Classification:
EL15-036b

2015 – 2016 QX80; FUEL GAUGE DROPS QUICKLY AFTER TANK FILLED AND SHORT DRIVE

APPLIED VEHICLES: 2015-2016 QX80 (Z62)

Figure 1

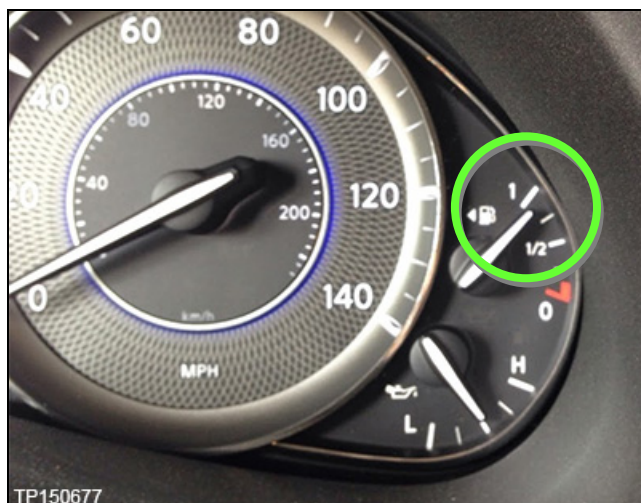
After filling up the fuel tank to “full”, the fuel gauge will drop down to about $\frac{7}{8}$ (see Figure 1) quickly after a short drive.

Replace the Combination Meter.

- Look up the Combination Meter part number using the VIN with WIN/FAST or equivalent, and then order the corresponding **New Part** number listed in the Parts Information on next page through Model Electronics.
- Refer to the Electronic Service Manual (ESM), section **MWI – Meter, Warning Lamp & Indicator** for removal and reassembly.
